## **Staff Changes**

This section covers changes proposed by Planning Staff to correct errors and to reflect changes in conversion philosophy based on discussions with the PHED Committee and the Planning Board.

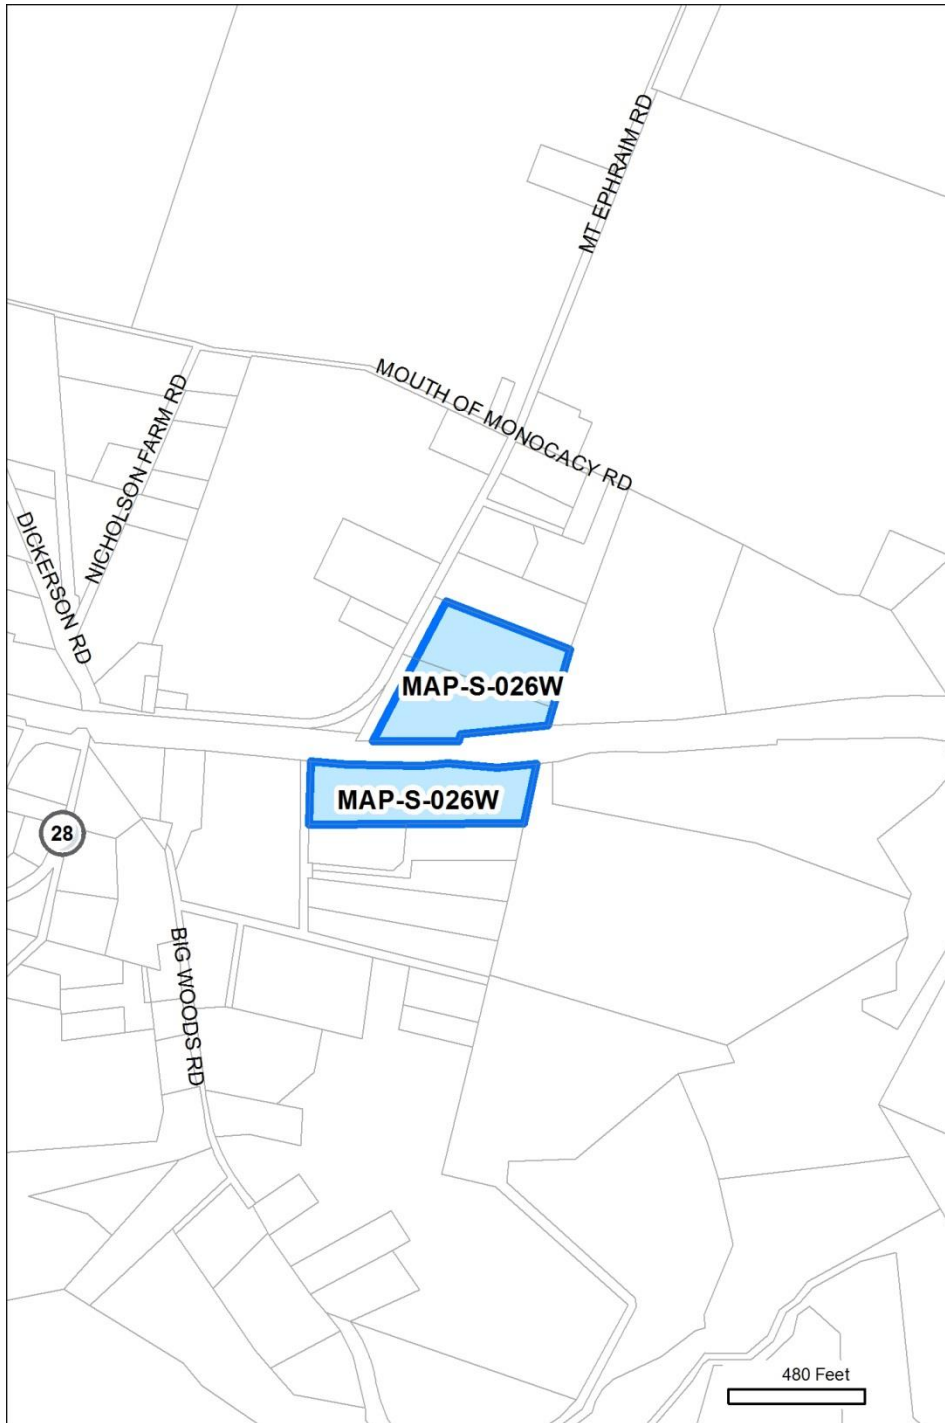
<b>Unique ID:</b> MAP-S-026W		staff rec. change
<b>Master Plan ID:</b> n/a		
<b>Master Plan:</b>	Preservation of Agricultural and Rural Open Sp	
<b>Location:</b>		
<b>Existing Zone:</b>	I-1	
<b>Proposed Conv:</b> (5/2)	<del>IM-2.5 H-120</del>	
<b>Prop. Revised Conv:</b>	IM-2.5 H-50	
<b>Category:</b>	Staff Recommendation	
<b>Modifications</b>	<b>Zone Group:</b>	No change
	<b>Overall FAR:</b>	No change
	<b>Comm'l FAR:</b>	-
	<b>Resid'l FAR:</b>	-
	<b>Height:</b>	Reduced to 50'
<b>Reason for change:</b>		
<p><i>Since the 5/2 conversion was approved by the Planning Board, staff has received comment from the public and upon further review, believes that the 120' height granted as part of the 5/2 conversion is inappropriate.</i></p> <p><i>The current zoning ordinance allows building heights up to 120' for an "Employment Center", unless the master plan specifically states that an "Employment Center" is inappropriate for the zone – only two master plans contain this restriction.</i></p> <p><i>This provision has been in the code since the last comprehensive revision. Further analysis indicates that buildings up to 120' have not been constructed in the I-1 zone under this provision. Staff proposes a height of 50' for all I-1 property converted to the I-M zone.</i></p>

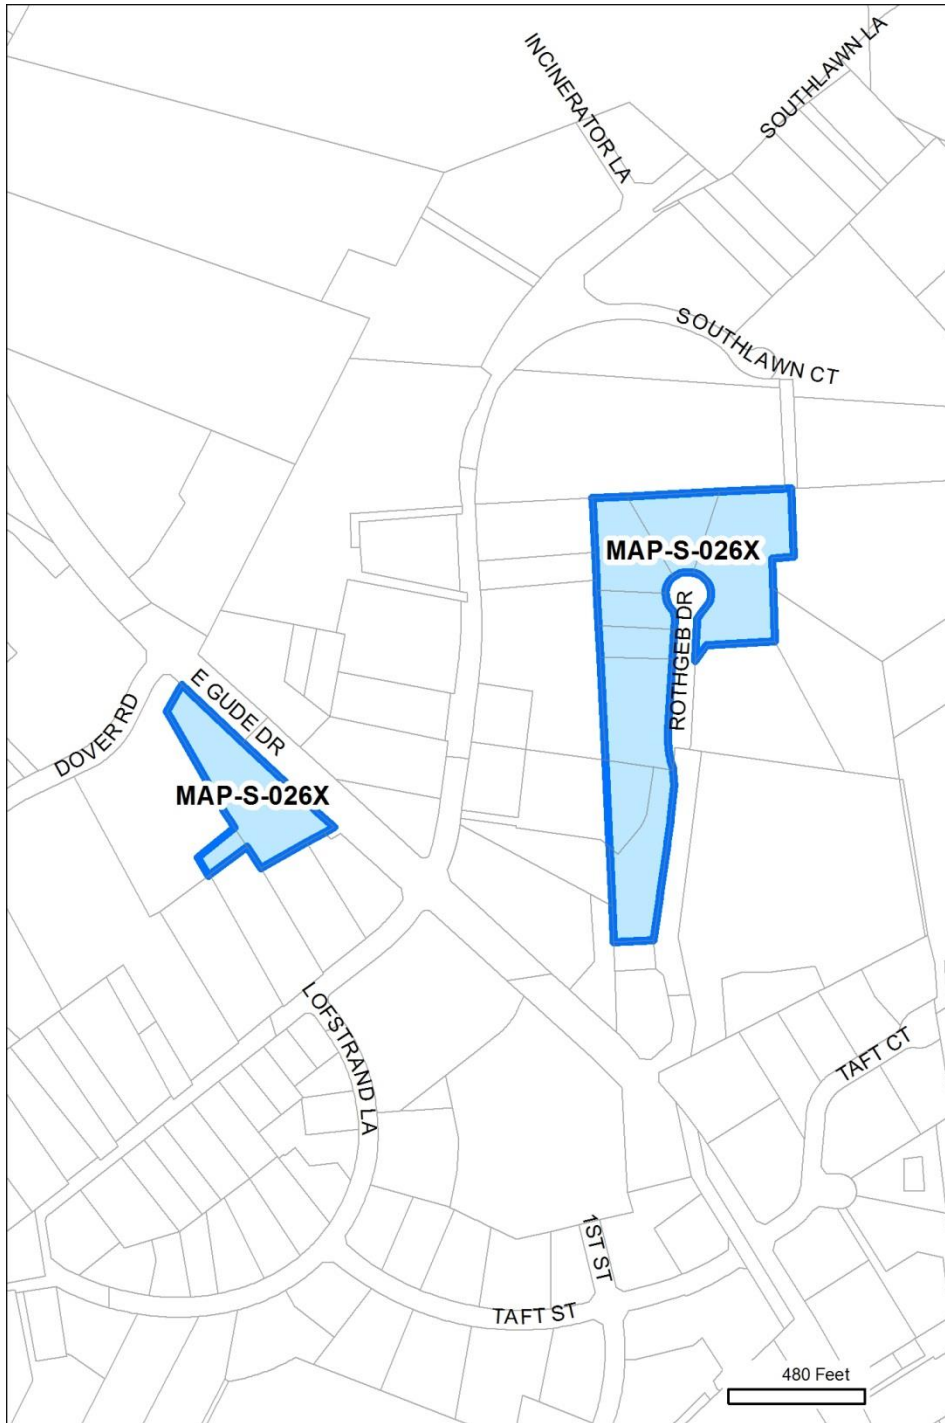
<b>Unique ID:</b> MAP-S-026X		staff rec. change
<b>Master Plan ID:</b> n/a		
<b>Master Plan:</b>	Upper Rock Creek	
<b>Location:</b>		
<b>Existing Zone:</b>	I-1	
<b>Proposed Conv:</b> (5/2)	<del>IM-2.5 H-120</del>	
<b>Prop. Revised Conv:</b>	IM-2.5 H-50	
<b>Category:</b>	Staff Recommendation	
<b>Modifications</b>	<b>Zone Group:</b>	No change
	<b>Overall FAR:</b>	No change
	<b>Comm'l FAR:</b>	-
	<b>Resid'l FAR:</b>	-
	<b>Height:</b>	Reduced to 50'
<b>Reason for change:</b>		
<p><i>Since the 5/2 conversion was approved by the Planning Board, staff has received comment from the public and upon further review, believes that the 120' height granted as part of the 5/2 conversion is inappropriate.</i></p> <p><i>The current zoning ordinance allows building heights up to 120' for an "Employment Center", unless the master plan specifically states that an "Employment Center" is inappropriate for the zone – only two master plans contain this restriction.</i></p> <p><i>This provision has been in the code since the last comprehensive revision. Further analysis indicates that buildings up to 120' have not been constructed in the I-1 zone under this provision. Staff proposes a height of 50' for all I-1 property converted to the I-M zone.</i></p>

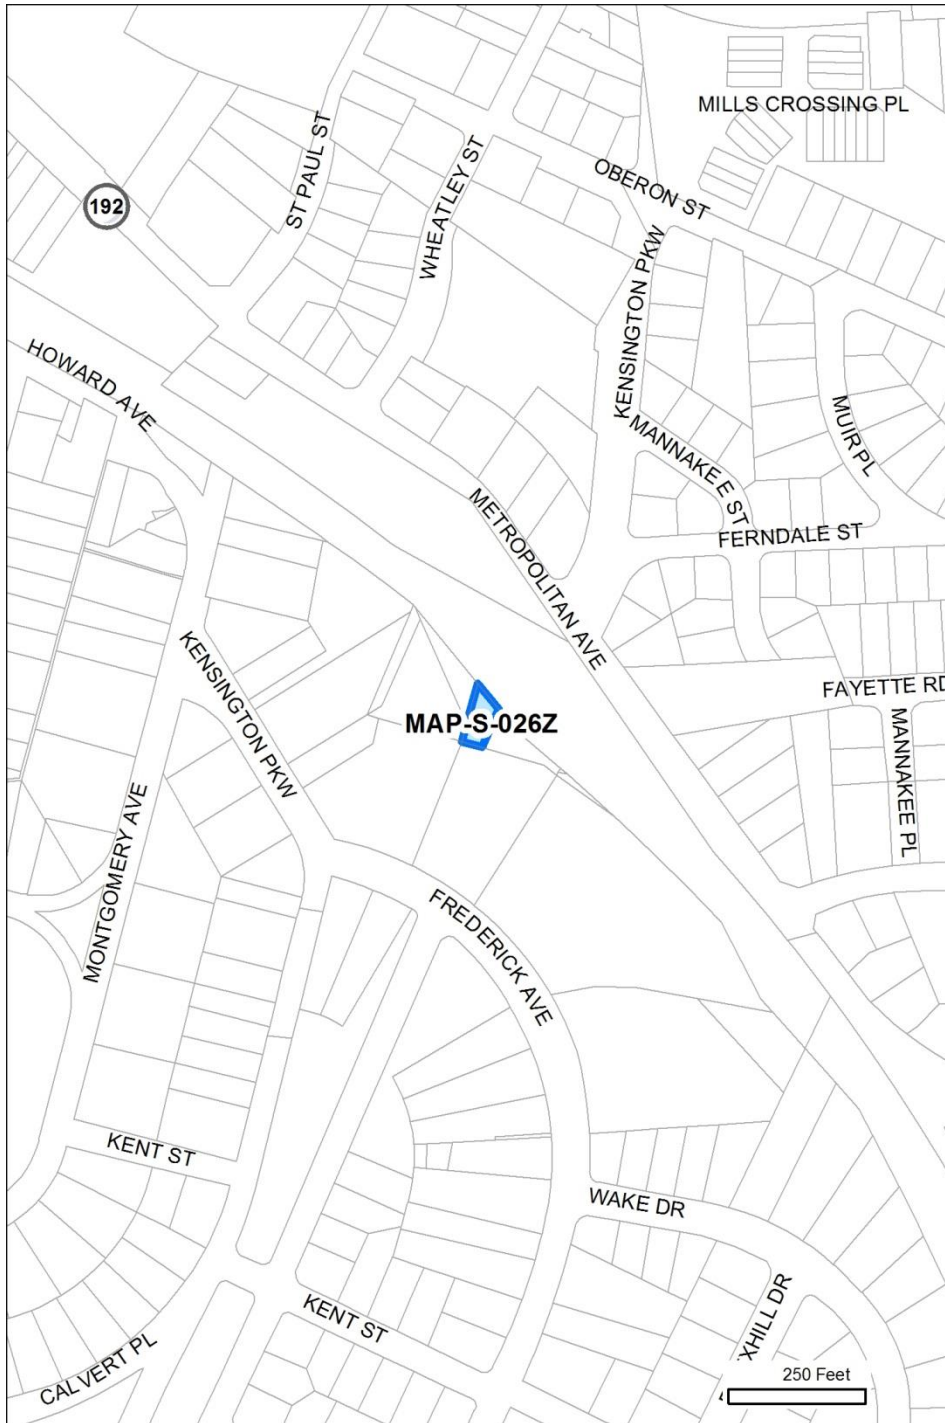
<b>Unique ID:</b> MAP-S-026Z		staff rec. change
<b>Master Plan ID:</b> n/a		
<b>Master Plan:</b>		Kensington
<b>Location:</b>		
<b>Existing Zone:</b>		I-1
<b>Proposed Conv: (5/2)</b>		<del>IM-2.5 H-120</del>
<b>Prop. Revised Conv:</b>		IM-2.5 H-50
<b>Category:</b>		Staff Recommendation
<b>Modifications</b>	<b>Zone Group:</b>	No change
	<b>Overall FAR:</b>	No change
	<b>Comm'l FAR:</b>	-
	<b>Resid'l FAR:</b>	-
	<b>Height:</b>	Reduced to 50'
<b>Reason for change:</b>		
<p><i>Since the 5/2 conversion was approved by the Planning Board, staff has received comment from the public and upon further review, believes that the 120' height granted as part of the 5/2 conversion is inappropriate.</i></p> <p><i>The current zoning ordinance allows building heights up to 120' for an "Employment Center", unless the master plan specifically states that an "Employment Center" is inappropriate for the zone – only two master plans contain this restriction.</i></p> <p><i>This provision has been in the code since the last comprehensive revision. Further analysis indicates that buildings up to 120' have not been constructed in the I-1 zone under this provision. Staff proposes a height of 50' for all I-1 property converted to the I-M zone.</i></p>

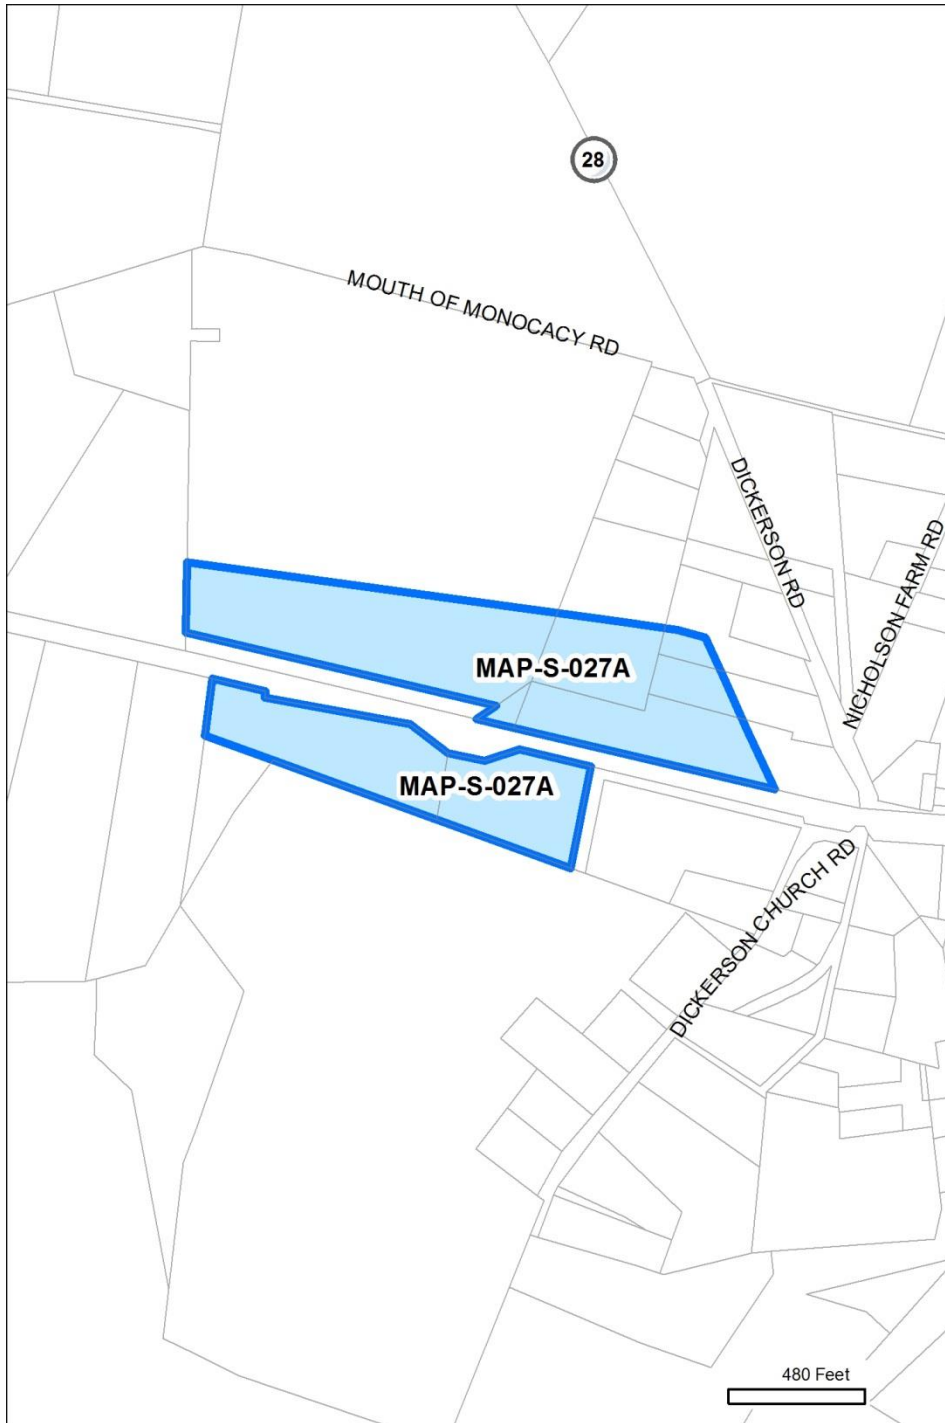
<b>Unique ID:</b> MAP-S-027A		staff rec. change
<b>Master Plan ID:</b> n/a		
<b>Master Plan:</b>	Preservation of Agricultural and Rural Open Sp	
<b>Location:</b>		
<b>Existing Zone:</b>	I-1	
<b>Proposed Conv:</b> (5/2)	<del>IM-2.5 H-120</del>	
<b>Prop. Revised Conv:</b>	IM-2.5 H-50	
<b>Category:</b>	Staff Recommendation	
<b>Modifications</b>	<b>Zone Group:</b>	No change
	<b>Overall FAR:</b>	No change
	<b>Comm'l FAR:</b>	-
	<b>Resid'l FAR:</b>	-
	<b>Height:</b>	Reduced to 50'
<b>Reason for change:</b>		
<p><i>Since the 5/2 conversion was approved by the Planning Board, staff has received comment from the public and upon further review, believes that the 120' height granted as part of the 5/2 conversion is inappropriate.</i></p> <p><i>The current zoning ordinance allows building heights up to 120' for an "Employment Center", unless the master plan specifically states that an "Employment Center" is inappropriate for the zone – only two master plans contain this restriction.</i></p> <p><i>This provision has been in the code since the last comprehensive revision. Further analysis indicates that buildings up to 120' have not been constructed in the I-1 zone under this provision. Staff proposes a height of 50' for all I-1 property converted to the I-M zone.</i></p>

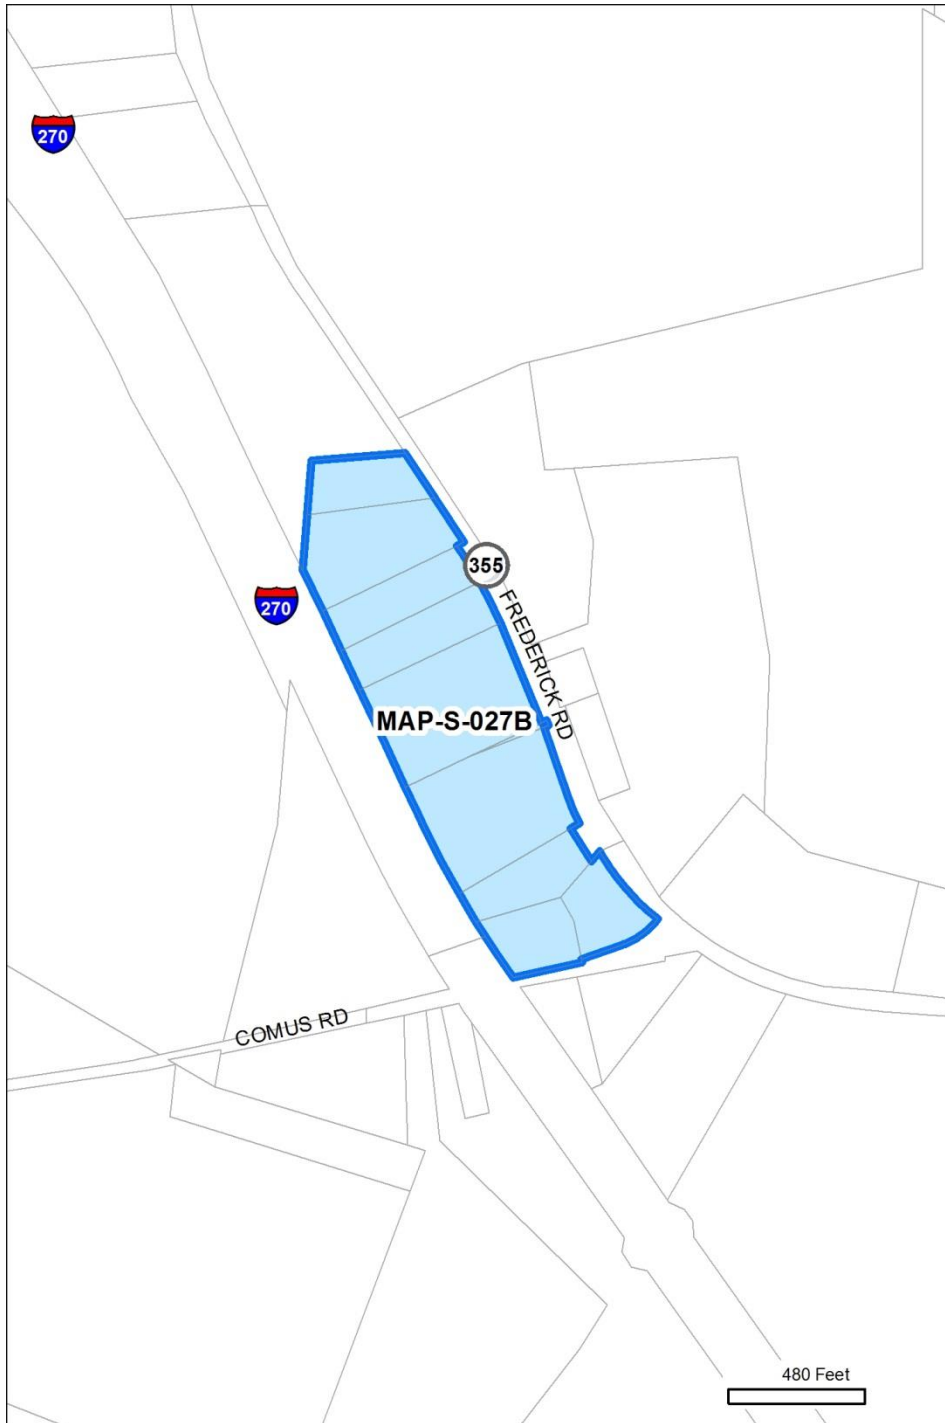
<b>Unique ID:</b> MAP-S-027B		staff rec. change
<b>Master Plan ID:</b> n/a		
<b>Master Plan:</b>	Clarksburg	
<b>Location:</b>		
<b>Existing Zone:</b>	I-1	
<b>Proposed Conv:</b> (5/2)	<del>IM-2.5 H-120</del>	
<b>Prop. Revised Conv:</b>	IM-2.5 H-50	
<b>Category:</b>	Staff Recommendation	
<b>Modifications</b>	<b>Zone Group:</b>	No change
	<b>Overall FAR:</b>	No change
	<b>Comm'l FAR:</b>	-
	<b>Resid'l FAR:</b>	-
	<b>Height:</b>	Reduced to 50'
<b>Reason for change:</b>		
<p><i>Since the 5/2 conversion was approved by the Planning Board, staff has received comment from the public and upon further review, believes that the 120' height granted as part of the 5/2 conversion is inappropriate.</i></p> <p><i>The current zoning ordinance allows building heights up to 120' for an "Employment Center", unless the master plan specifically states that an "Employment Center" is inappropriate for the zone – only two master plans contain this restriction.</i></p> <p><i>This provision has been in the code since the last comprehensive revision. Further analysis indicates that buildings up to 120' have not been constructed in the I-1 zone under this provision. Staff proposes a height of 50' for all I-1 property converted to the I-M zone.</i></p>

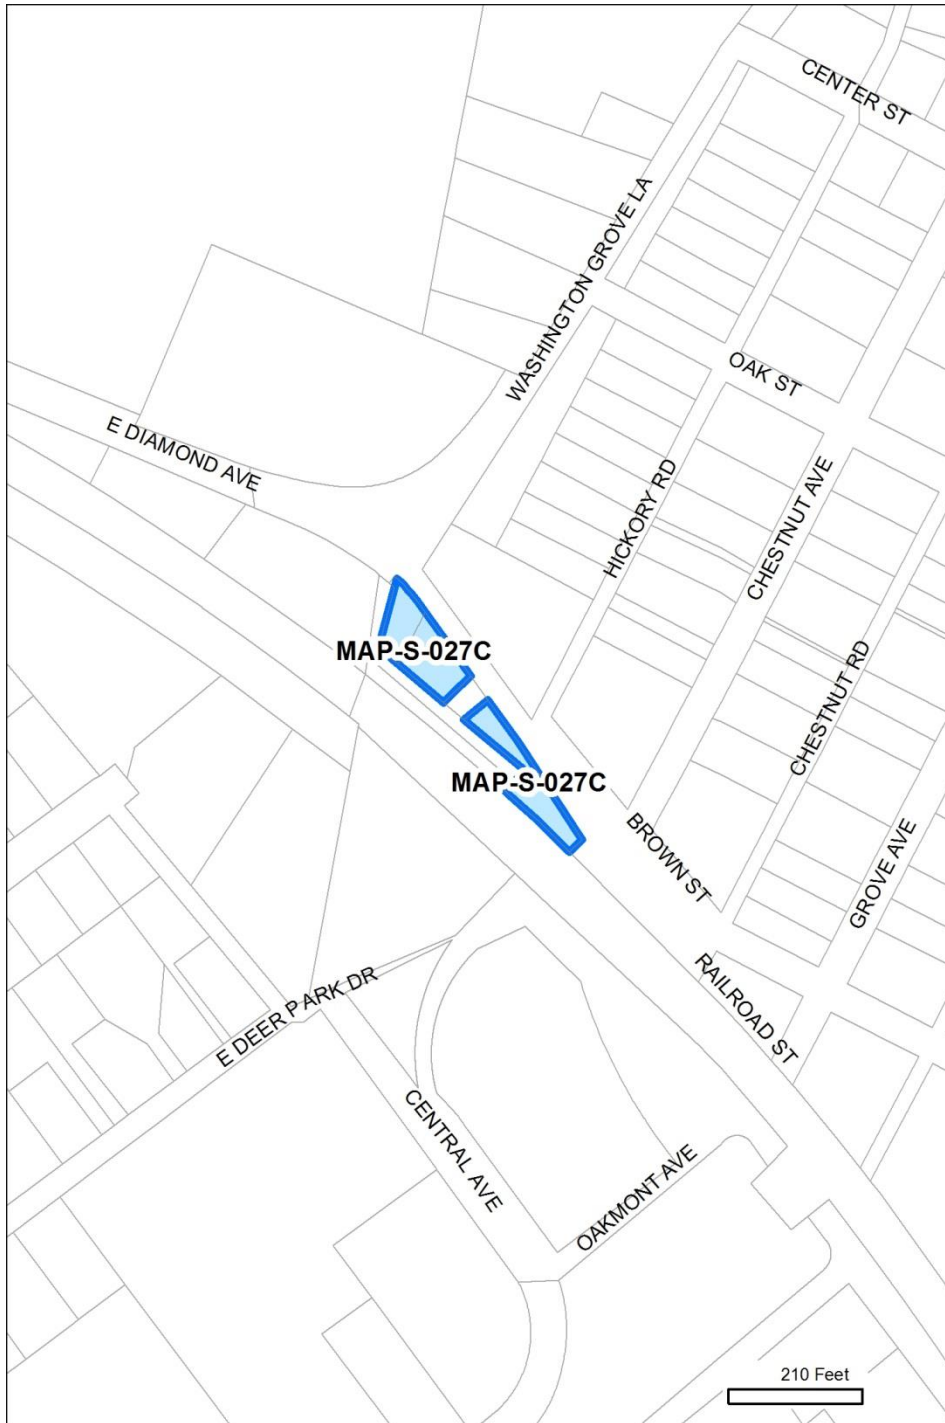
<b>Unique ID:</b> MAP-S-027C		staff rec. change
<b>Master Plan ID:</b> n/a		
<b>Master Plan:</b>	Great Seneca	
<b>Location:</b>		
<b>Existing Zone:</b>	I-1	
<b>Proposed Conv:</b> (5/2)	<del>IM-2.5 H-120</del>	
<b>Prop. Revised Conv:</b>	IM-2.5 H-50	
<b>Category:</b>	Staff Recommendation	
<b>Modifications</b>	<b>Zone Group:</b>	No change
	<b>Overall FAR:</b>	No change
	<b>Comm'l FAR:</b>	-
	<b>Resid'l FAR:</b>	-
	<b>Height:</b>	Reduced to 50'
<b>Reason for change:</b>		
<p><i>Since the 5/2 conversion was approved by the Planning Board, staff has received comment from the public and upon further review, believes that the 120' height granted as part of the 5/2 conversion is inappropriate.</i></p> <p><i>The current zoning ordinance allows building heights up to 120' for an "Employment Center", unless the master plan specifically states that an "Employment Center" is inappropriate for the zone – only two master plans contain this restriction.</i></p> <p><i>This provision has been in the code since the last comprehensive revision. Further analysis indicates that buildings up to 120' have not been constructed in the I-1 zone under this provision. Staff proposes a height of 50' for all I-1 property converted to the I-M zone.</i></p>
